Model: iR2200/2800/3300/
iR2200i/iR3300i

Ref. No. : FF-T01-L5-000035-01

Location: DC Controller PCB Assembly

Subject: Masking Flash DIMM-ROM of DC Controller PCB Assembly

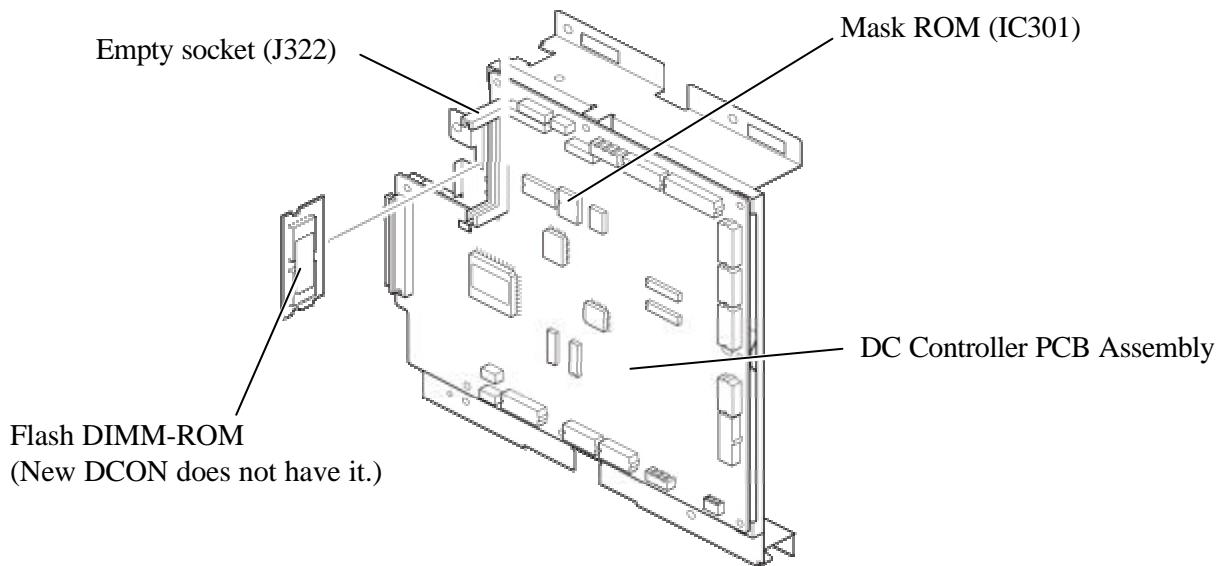
Reason: For manufacturing reasons, masking Flash DIMM-ROM of DC Controller PCB was carried out.

Detail: The contents of Flash DIMM-ROM will be masked and masked ROM (IC301) will be attached directly to DC Controller PCB. Therefore, Flash DIMM-ROM of DC Controller will be abolished. Former Socket (J322) of Flash DIMM-ROM is empty. With the deletion of the flash DIMM-ROM, the part number of the DC controller PCB remains unchanged.

Leave former Flash DIMM-ROM as a service parts and they will be supplied continuously.
